LATIOG TRAILS - FILING NO. 9	GRADING AND EROSION CONTROL PLAN	DESIGNED BY	APL
		DRAWN BY	RWK
SHEET	7	OF	14
JOB NO.	25175.01

LATIGO TRAILS - FILING NO. 9

GRADING AND EROSION CONTROL PLAN

SHEET 8 OF 14

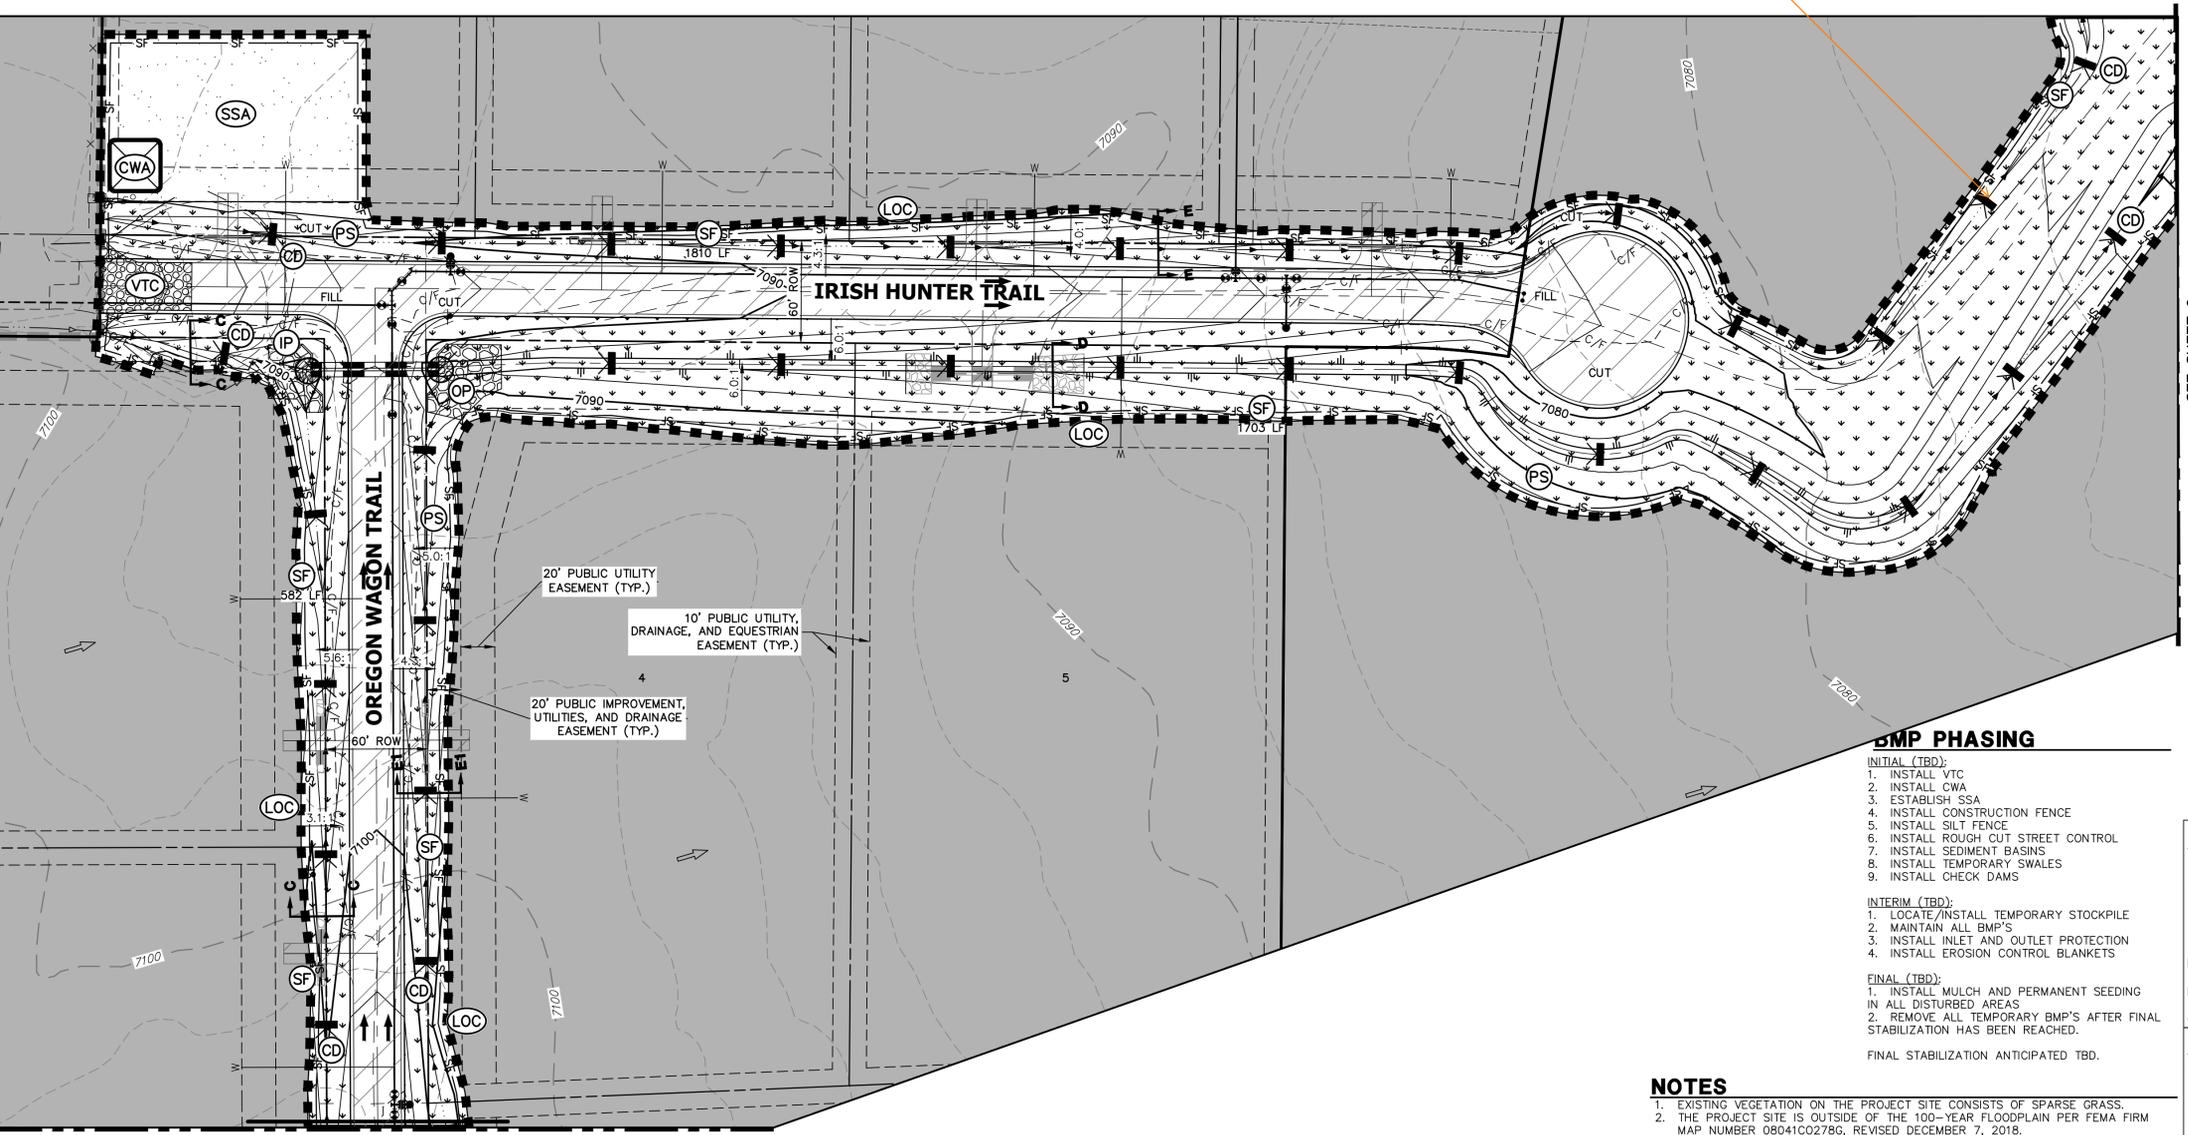
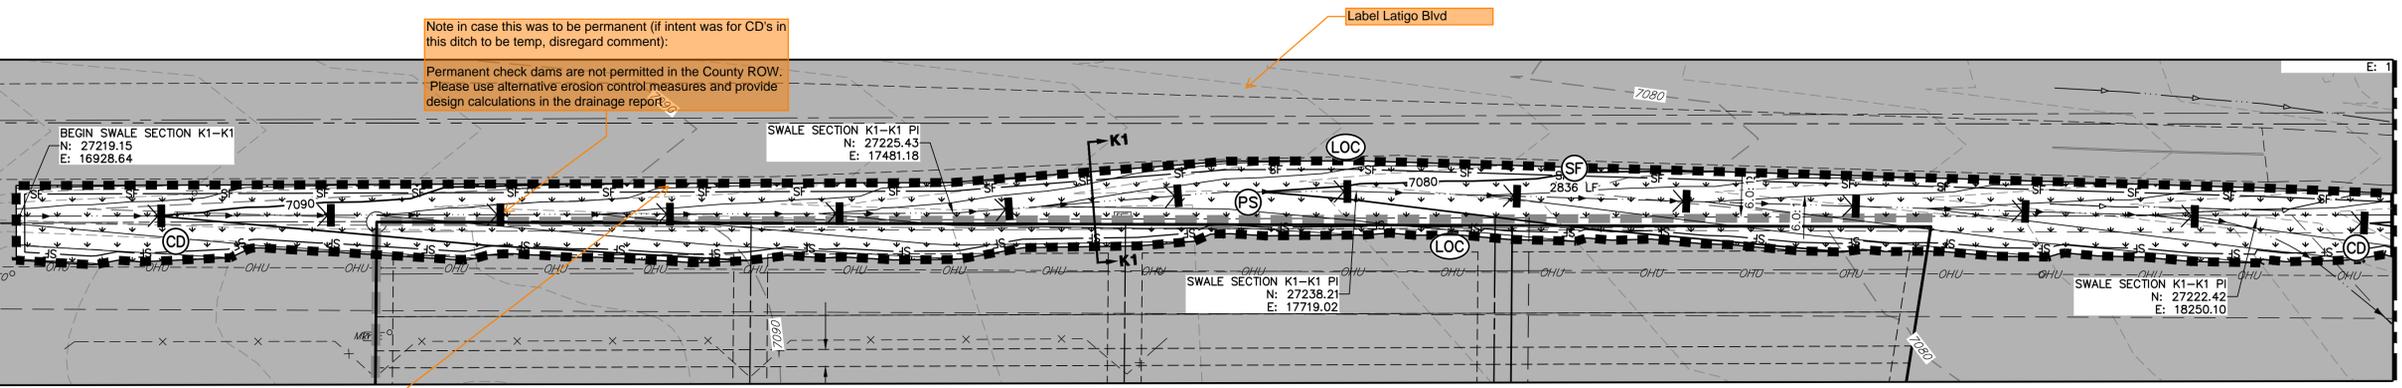
Checklist Item "o" --- At this location and others for this project:

Private Offsite Grading: Need owner permission to grade offsite. Provide copy of owner permission to EPC. Per Item O on GEC Checklist.
 - For a small amount of grading, applicant to submit as discussed above.
 - For a larger amount of grading, owner AND applicant will need to sign GEC/CD's.

Public Offsite Grading: Call out as offsite grading, to be approved by the City of Colorado Springs (or EPC).

Check dams to be installed a minimum of every 1.5' of vertical fall. Notate spacing and/or include a table for multiple slopes, based on your selected detail, per the example table shown to the right.

Slope of Ditch Flow Line	2%	3%	4%	5%	6%	Reference	Type
Spacing (ft) (H = 0.5ft)	25	16.7	12.5	10	8.3	CDOT, MHFD, DCMv2	SCL (9" Straw Wattle, buried 3")
Spacing (ft) (H = 1.5ft)	75	50	37.5	30	25	MHFD	Rock
Spacing (ft) (H = 2.0ft)	100	67	50	40	33	CDOT	Rock
Spacing (ft) (H = to convey 2-yr flow)	TBD	TBD	TBD	TBD	TBD	DCMv2	Rock
